Groundwater Application Review Summary Form

Application # G- 18908 re-review

WATER RESOURCES DEPARTMENT

A. GENERAL INFORMATION: Applicant's Name: Fruitland, LLC County: MARION

D1. Well #: 1 Logid: MARI 17438

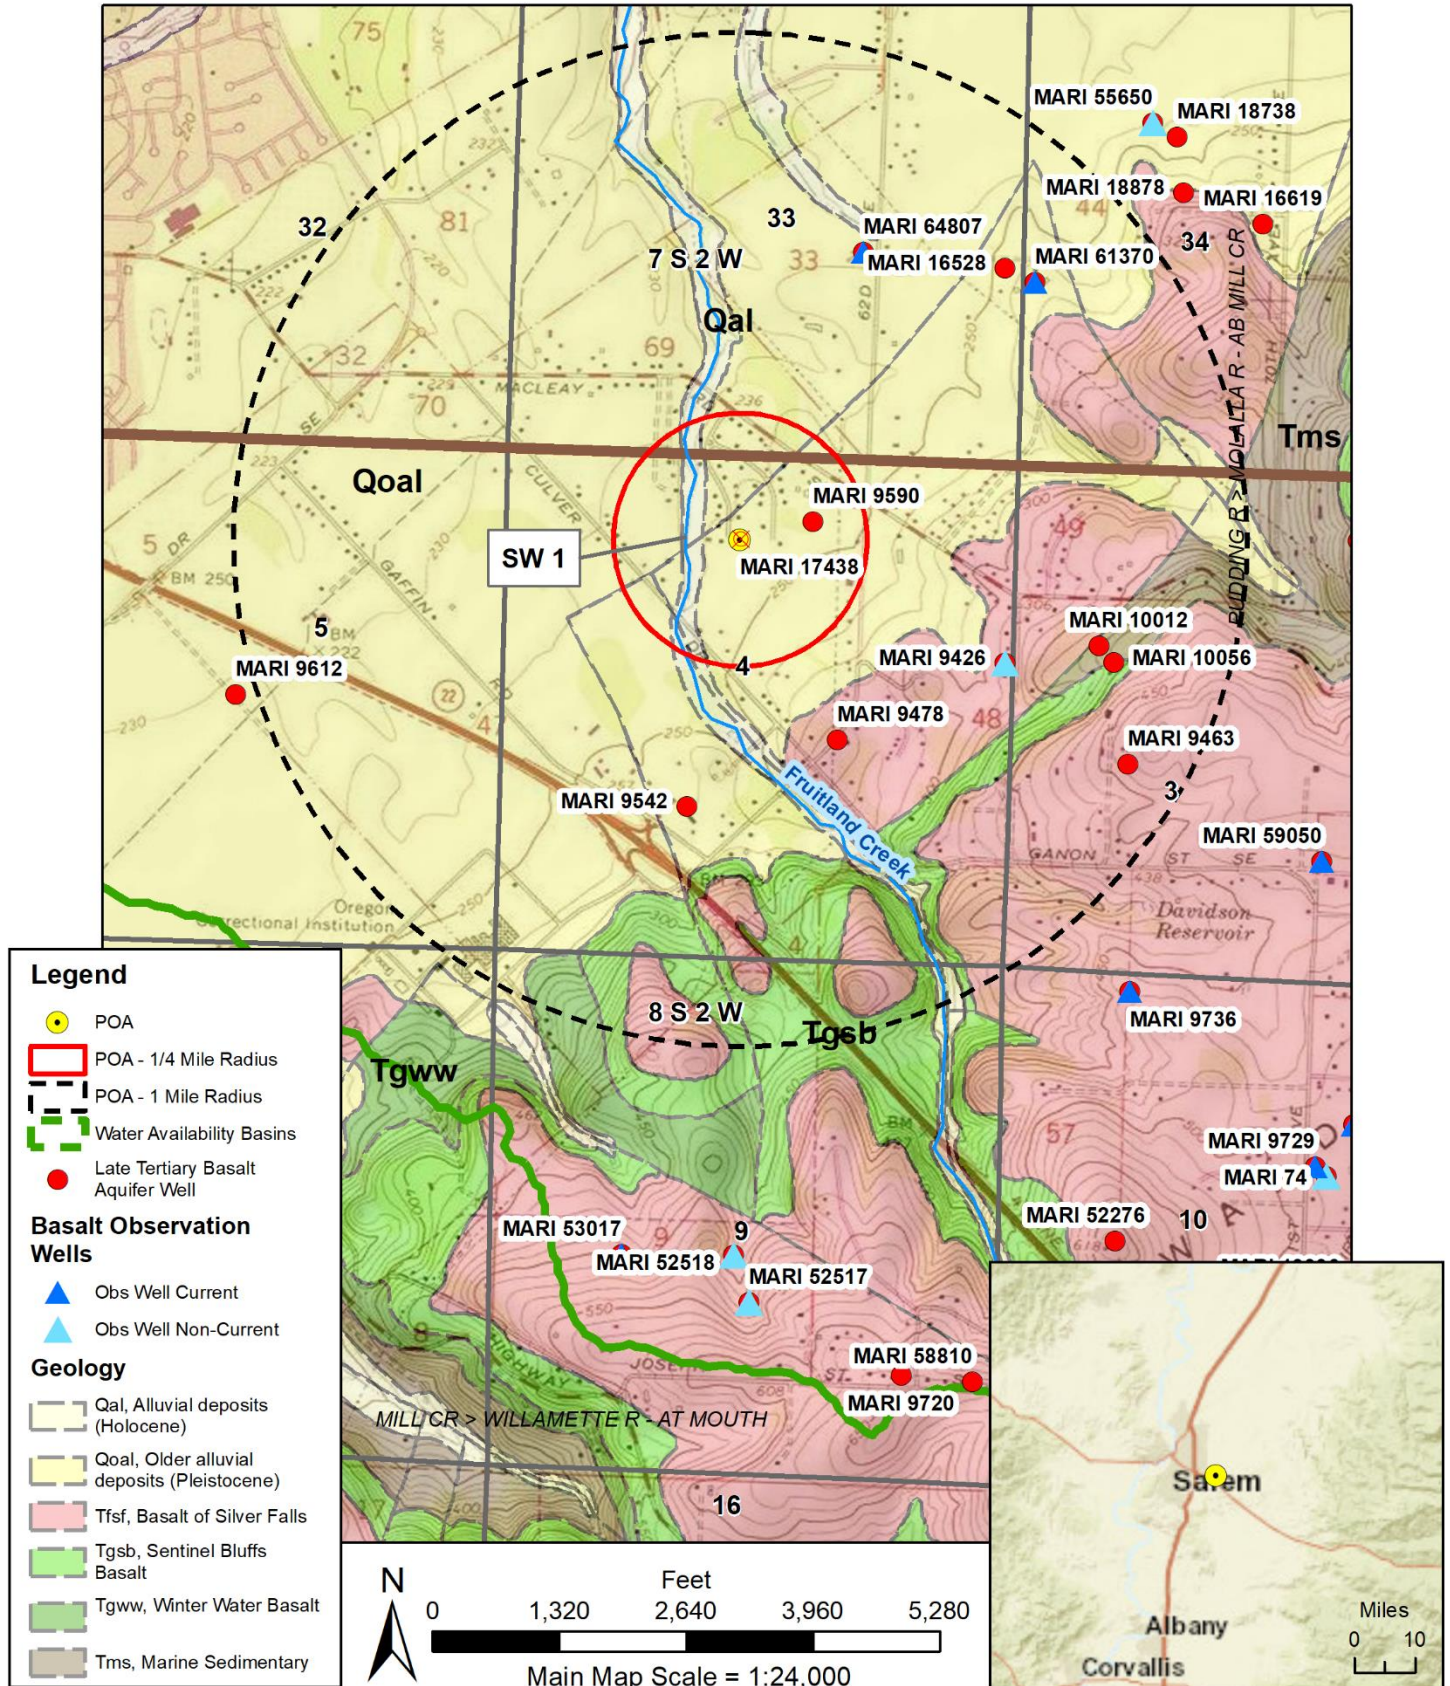
D2. **THE WELL does not appear to meet current well construction standards based upon:**

D3. **THE WELL construction deficiency or other comment is described as follows:** The well appears to be open to both the alluvial aquifer system ("Sandy Clay w Gravel", depth 73-94 ft bls, static water level [SWL] 21 ft bls) and the Columbia River Basalt (CRB) aquifer system ("Basalt Fractured", depth 183-193 ft bls, SWL 27 ft bls) (see attached Well Construction Diagram), possibly allowing for commingling. The seal ("Neat Cement") extends only to 35 ft bls; however, competent basalt ("Basalt Hard Med") is not reported until 106 ft bls, with at least one alluvial water-bearing zone in the intervening depths. The application indicates "Basalt" as the target aquifer. Based on the well log for MARI 17438 and the Well Construction Rules (OAR 690-200 and 690-210), the seal for MARI 17438 should extend at least 5 ft into hard, dense basalt – to at least 111 ft bls.

D4. **Route to the Well Construction and Compliance Section for a review of existing well construction.**

Hydrographs

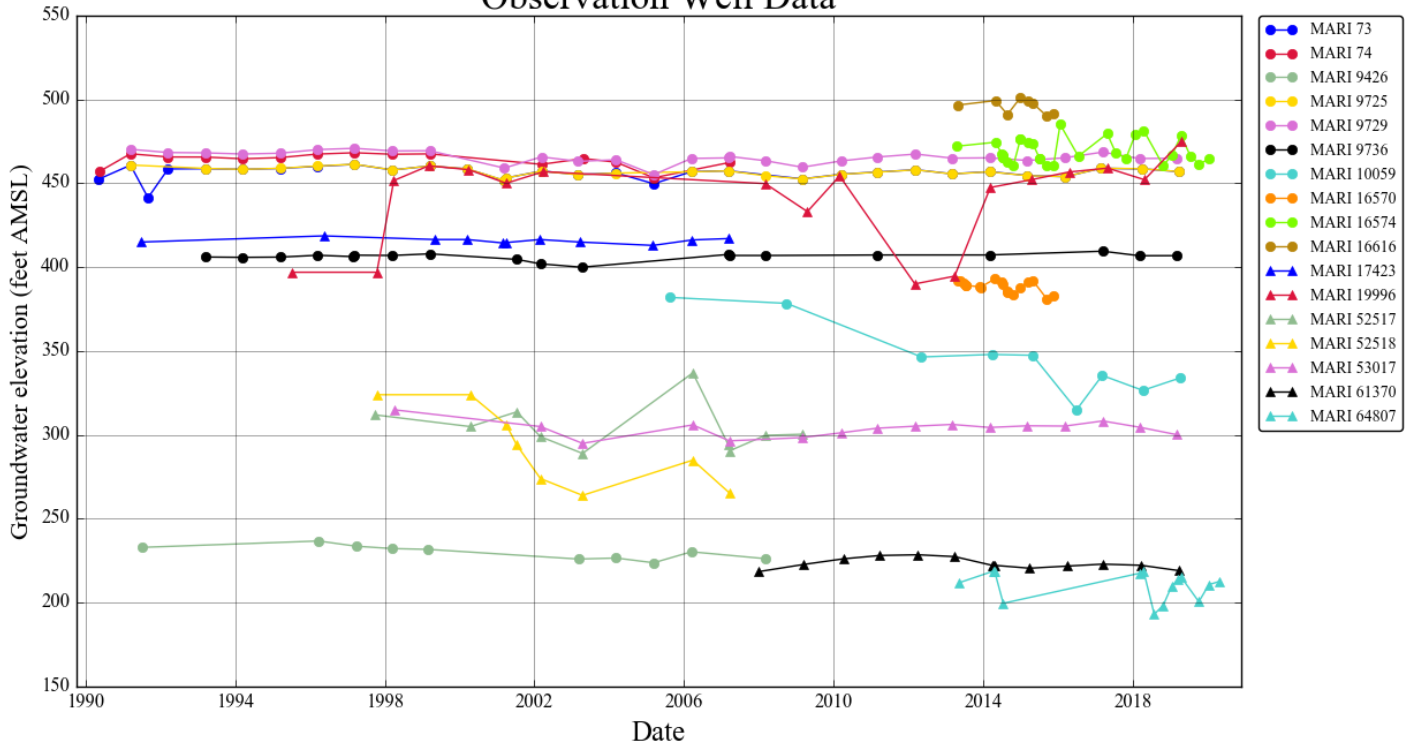
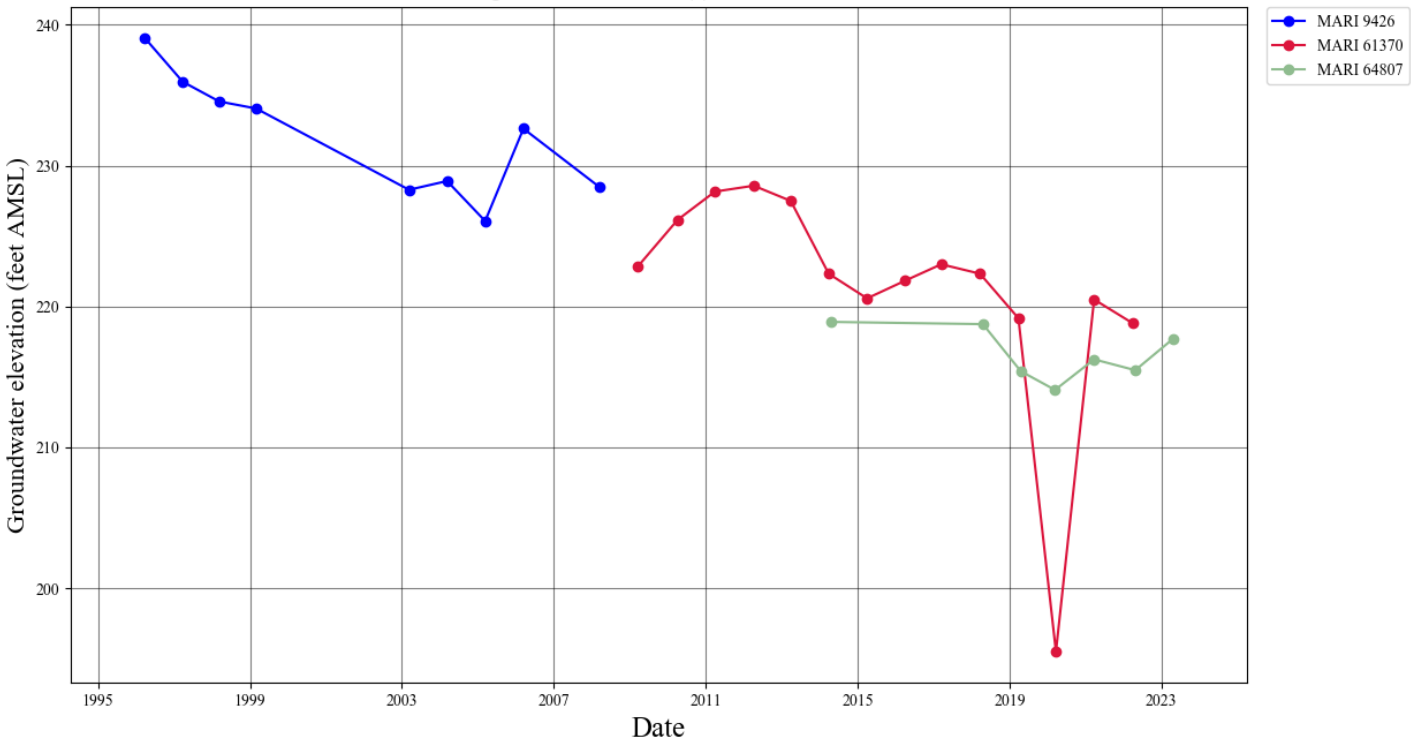
Reported water levels in this area indicate general stability within the basalt aquifer system, although some wells nearest to the proposed POA do indicate modest declines (see attached Hydrographs). Due to the unknown degree of compartmentalization in this area as well as the potential for the basalt aquifer system to contain multiple, hydraulically-distinct aquifers stacked on top of each other, the extent to which broader aquifer system trends reflect the status of the aquifer tapped by the proposed POA is unknown. As such, the conditions specified above are strongly recommended. Additionally, the following Special Conditions are recommended:
